From: Felicity Crocker
Sent: 4/02/2025 10:42:58 PM
To: Council Northernbeaches Mailbox
Subject: TRIMMED: Submission re: DA2024/1814 at 20 McDonald St Freshwater
Attachments: Submission re 20 McDonald Street Freshwater DA 2024-1814 Crocker.docx;

**Re: Submission for proposed works at 20 McDonald Street Freshwater
(Application number DA2024/1814)**

Figure 3: Wall Height non-compliance.

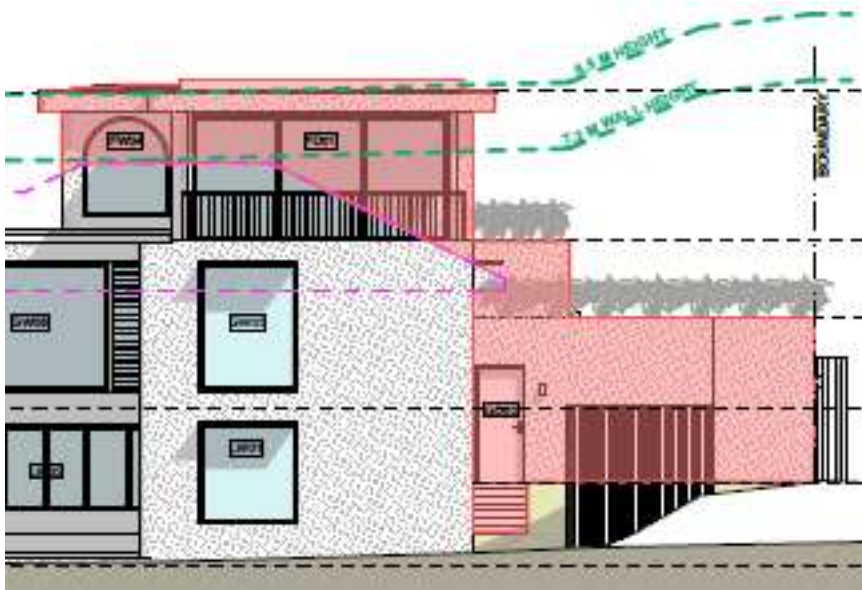
As a result of the max building height non-compliance, a wall height non-compliance has been created to the North, East and West elevations (Figures 3, 4 & 5). This has also added to non-compliance with the building envelopes of the Eastern and Western elevations. This creates a design that has excessive bulk and a scale that is not consistent with WLEP (Ref; WLEP Clause 4.3 Objective below) and the neighbouring properties, impacting the amenity and creating privacy issues at 18 McDonald Street Freshwater and surrounding neighbours.

Figure 7: East façade envelope non-compliance.

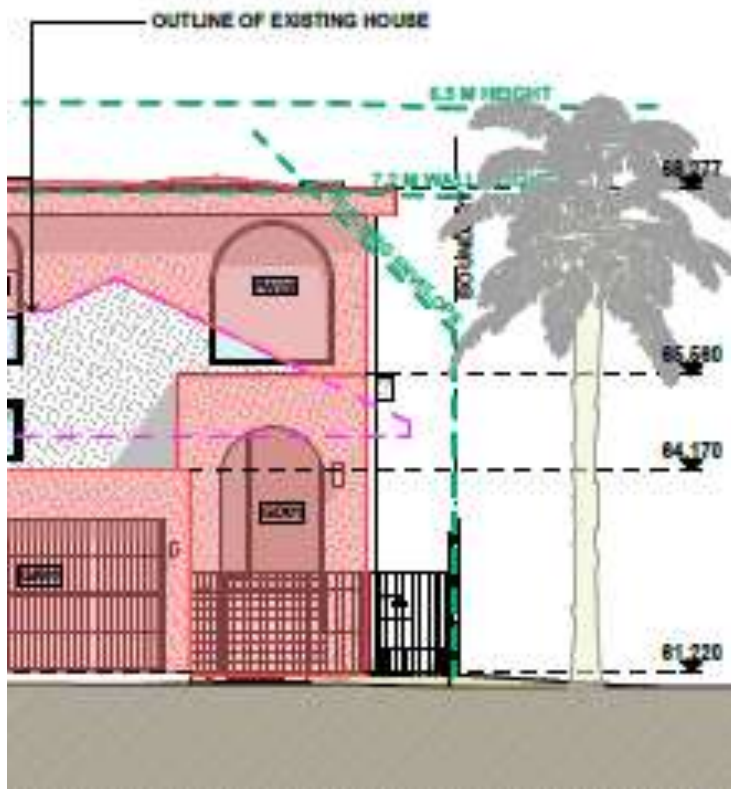
Both the East and West elevations of the proposed third floor addition confirm the non-compliance with the WDCP Clause B3. Under this clause, buildings must be sited within a building envelope determined by projecting planes at 45 degrees from a height above ground level (existing) at the side boundaries. The proposed upper floor is outside envelope on the East and the West elevations for the entire horizontal length of the proposed third floor (Figure 7 & 8).

Whilst the West elevation is also over the envelope to a lesser extent, the East facade is over two metres above the maximum building envelope for the entire third floor, an argument that is also made within the Clause 4.6 Request to vary the height development standard, and to the incompatible bulk and scale, with the visual presentation of these elevations dominating the adjoining properties. Thus, reflecting the significant bulk and scale, that does not meet the objectives of this Clause.

Figure 9: Non articulated western elevation.

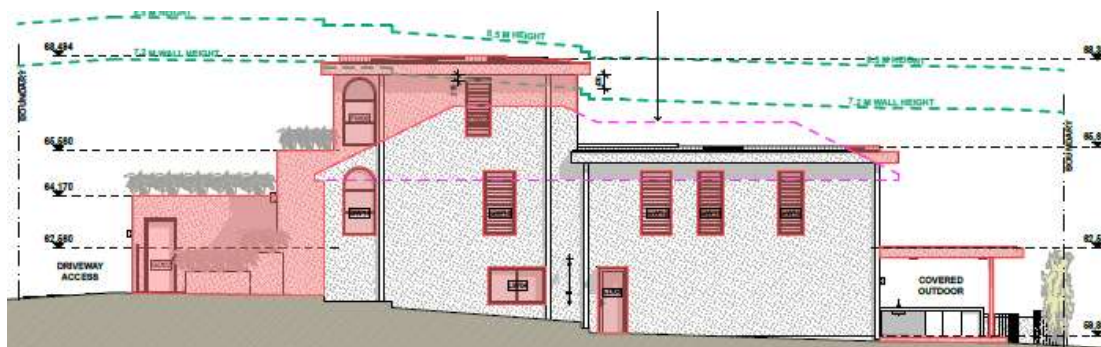
The proposed development lacks sufficient articulation along the non-compliant western facade, resulting in an unrelieved façade that exacerbates the perception of bulk and scale. The Warringah Development Control Plan (WDCP) D9 emphasizes the importance of articulation in reducing the dominance of structures, ensuring that new developments integrate harmoniously with their surroundings rather than imposing an overbearing presence on the streetscape and adjacent properties.

In this case, the development does not incorporate key articulation elements such as stepped building forms, varied materials, recesses, projections, and horizontal and vertical breaks (Figure 9). The absence of these design features results in a monolithic and overly dominant built form that lacks visual relief. Without appropriate modulation, the façade appears excessively bulky, with no transitional elements to soften its impact on the public domain or adjacent properties. This is particularly concerning given the non-compliance with height, setbacks, and bulk controls, which already contribute to an imposing structure.

To comply with the WDCP objectives, it is suggested the design include appropriate articulation techniques that break down the apparent mass and bulk of the building.

Figure 10: Landscape Plan.

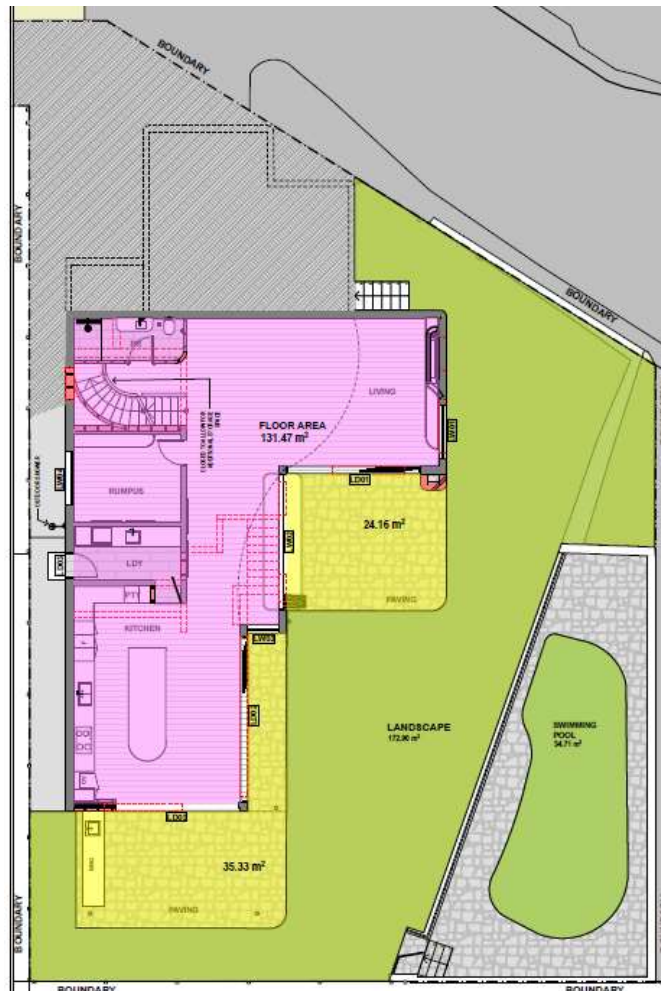
The proposal does not meet the minimum landscaped open space requirements, leading to a loss of greenery and reduction in environmental and aesthetic quality (Figure 10). Landscaped open space is a fundamental requirement in residential developments as it enhances urban amenity, promotes biodiversity, and improves stormwater management. The shortfall in landscaped areas in this proposal is inconsistent with the Warringah Development Control Plan (WDCP) objectives, which seek to maintain a balance between built form and natural elements.

The absence of adequate greenery compromises privacy screening, making neighbouring properties more susceptible to overlooking. Furthermore, the insufficient provision of permeable surfaces contributes to stormwater runoff issues, increasing pressure on local drainage infrastructure.
